Licence Number L4706/1972/17

Premises Muja Power Station

Date of Amendment 11 September 2018

Amendment

17. The Map of emission points and containment infrastructure in Schedule 1 of the Licence is updated with the map shown below:

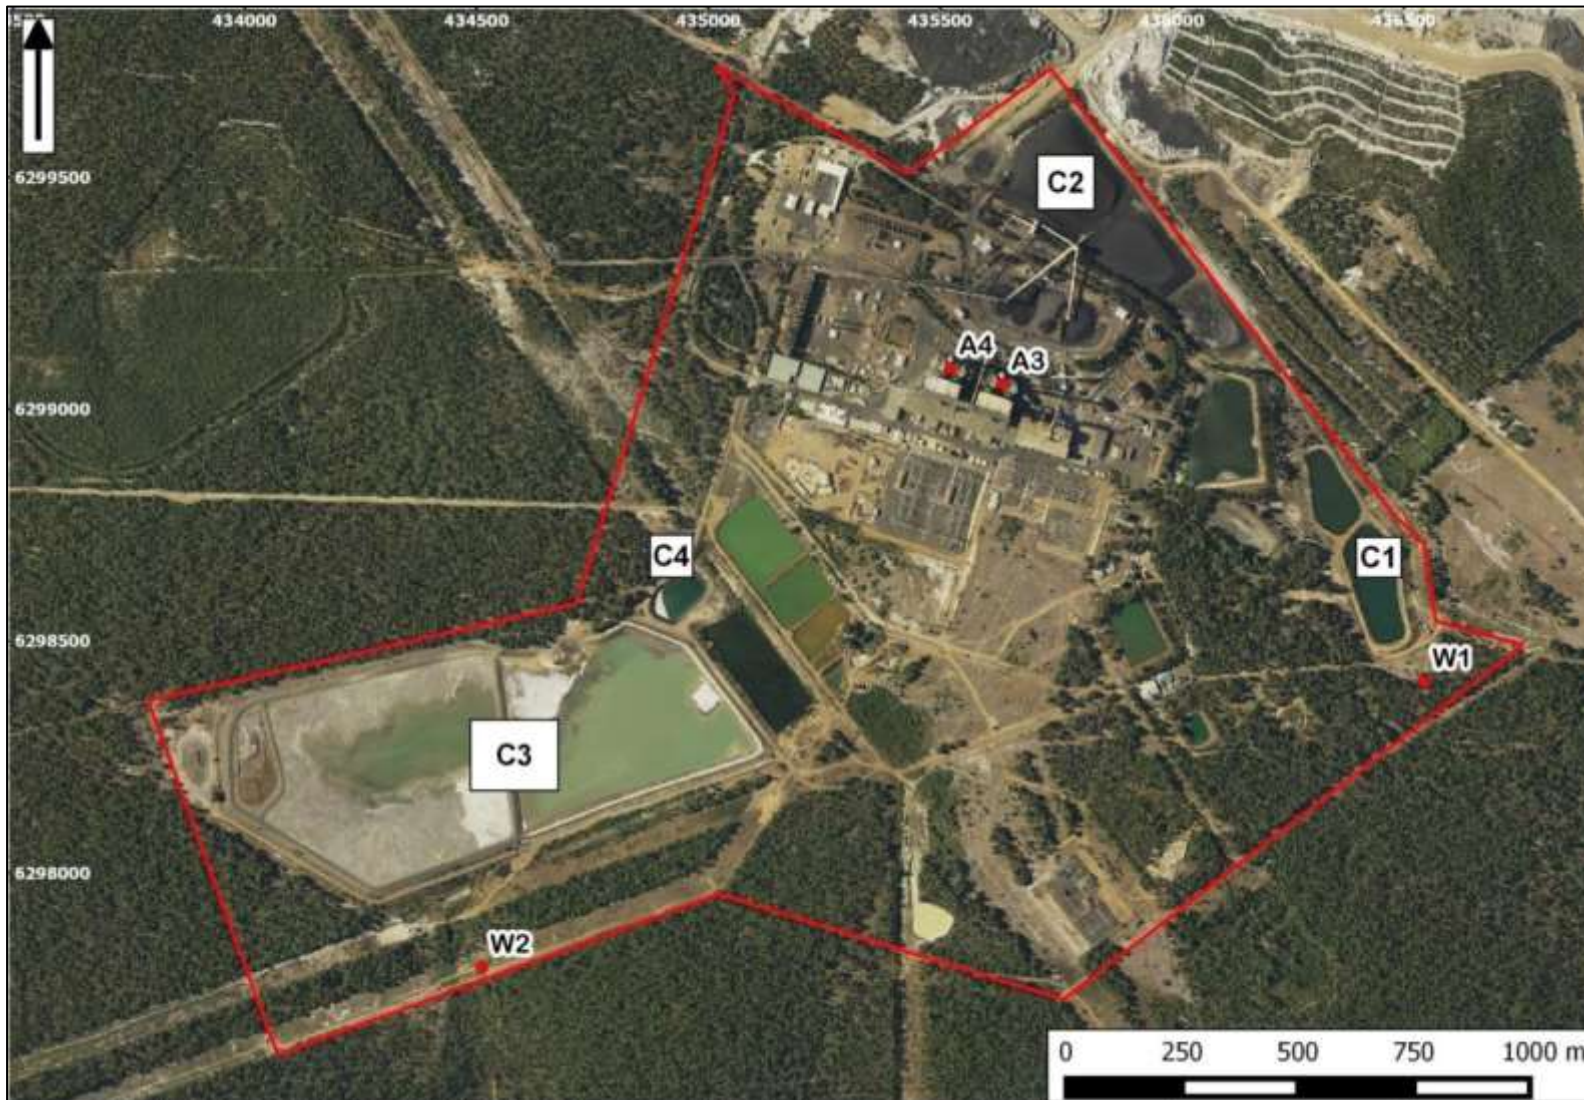
- The following specifications of the licence have been amended to remove the requirements associated with emissions from Muja A and B (emissions points A1 and A2):
 - Table 2.2.1 Emission points to air;
 - Table 2.2.2 Point source emission targets to air’
 - Table 2.2.3 Management actions (note: Table 2.2.3 has also been amended to specify emission points A3 and A4 which were not included in error;
 - Table 3.2.1 Monitoring of point source emissions to air; and
 - Schedule 2: Map of emission points and containment infrastructure.
- Table 3.2.1 has been amended to change the specified method of PM10 and PM2.5 stack monitoring from USEPA Method 201A to Method 5 or 17. The Licence Holder cannot comply with Method 201A due to the sample port size. The Delegated Officer considers that Method 5 or 17 are suitable alternatives.

18. The *Map of ambient air quality monitoring sites* in Schedule 1 of the Licence is updated with the map shown below:

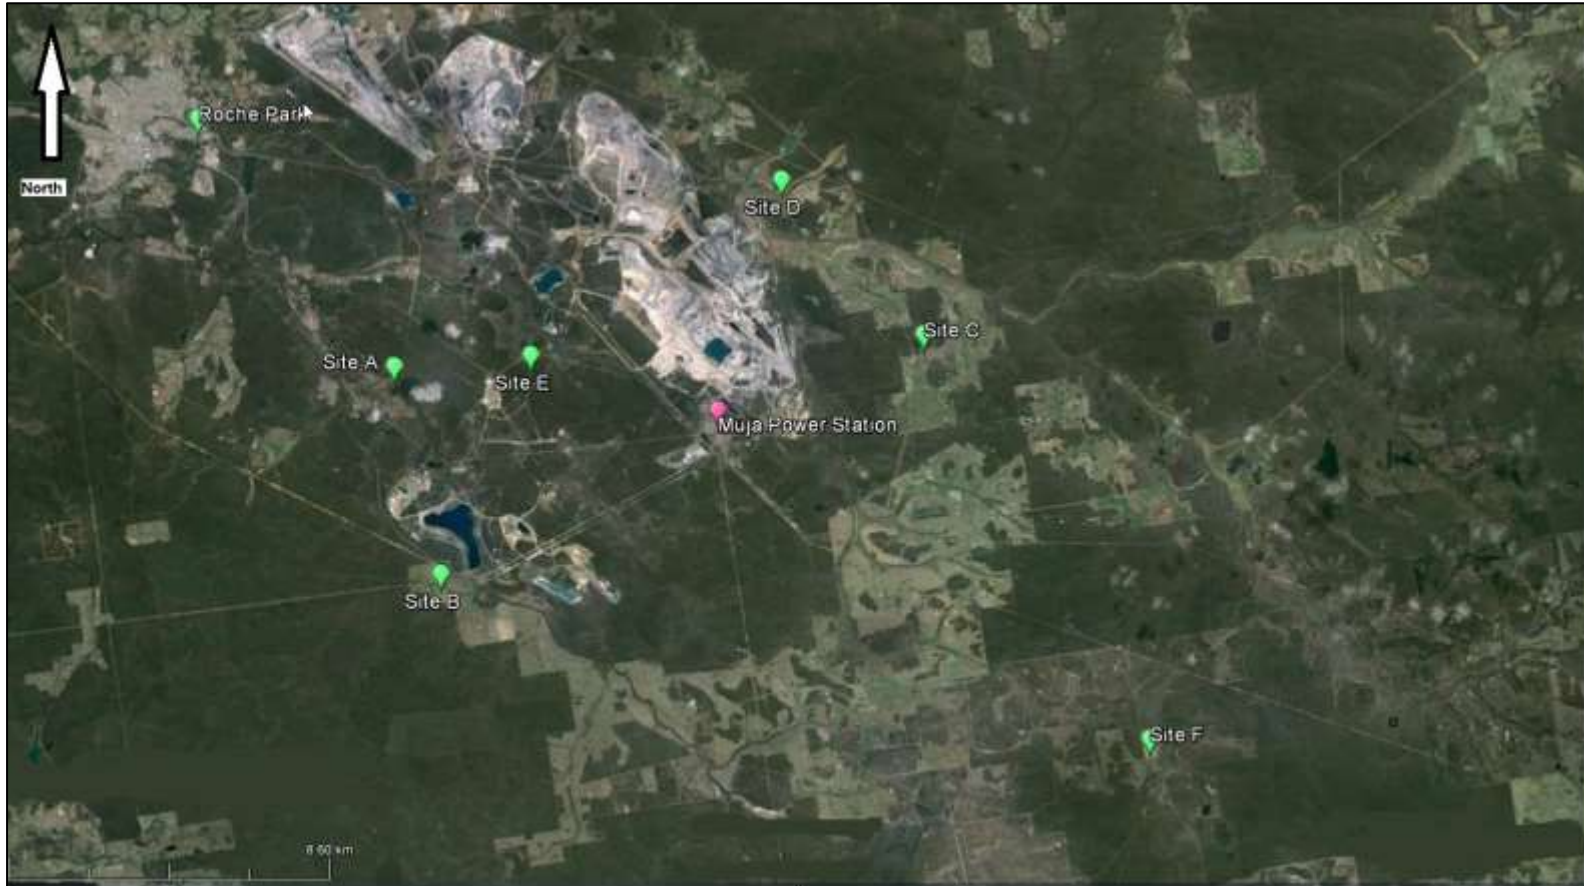
- The following specifications of the licence have been amended to include ambient air quality monitoring location MUJ5 (Muja F) which had been omitted from the licence in error:

- Schedule 2: Map of ambient air quality monitoring sites
- Table 3.5.1 has been updated as the Licence Holder cannot meet the location requirements of AS3580.14 due to the presence of large trees. This deviation has been accepted by DWER. The Licence Holder's request to amend Condition 3.5.2 has been refused as the condition relates to the calibration, operation and maintenance of the meteorological monitoring stations to achieve stated data availability requirements and not the location/design specification of the stations.
